Product change notification (PCN)

Title / short description	UK 6-FSI* foot area optimization
Affected article category	Terminal blocks
Change category	Form and appearance
Change number	PBE240168-00
Reason for PCN/PDN Revision

Optimization of the foot area of UK 6-FSI articles to improve handling efficiency.

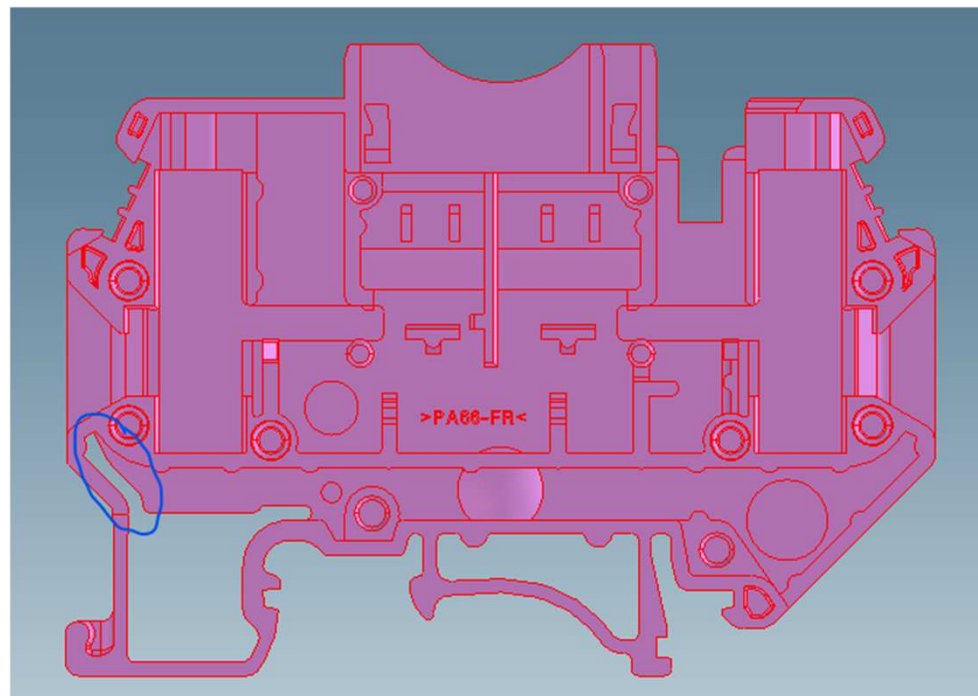
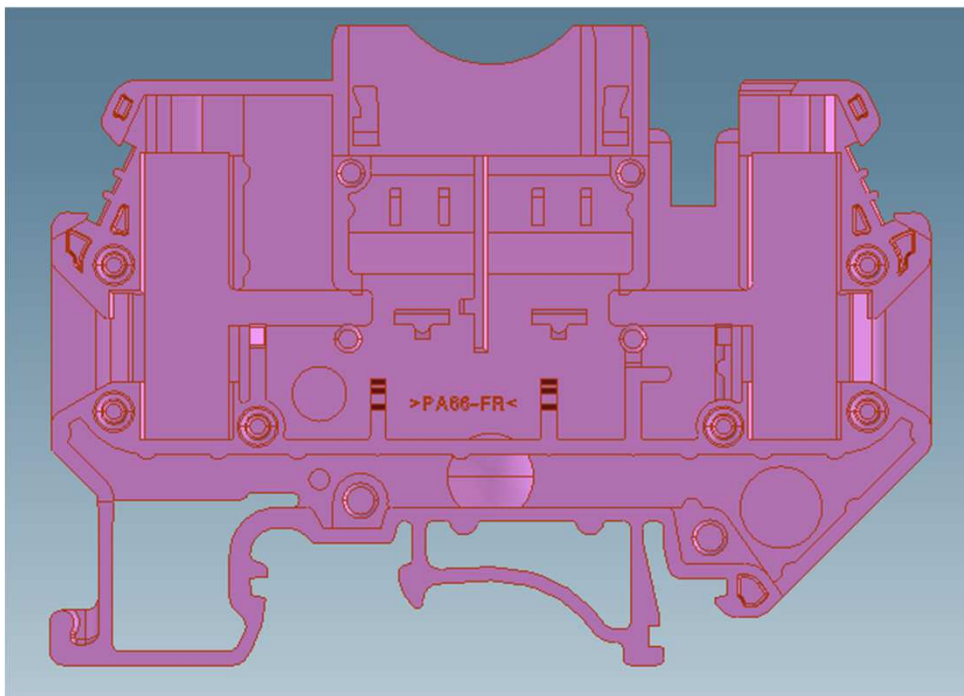
We have optimized the foot area of UK 6-FSI articles as part of our ongoing efforts to improve operational performance and streamline material handling processes. This enhancement has been implemented to increase handling efficiency, support smoother workflow execution, and contribute to overall productivity improvements.
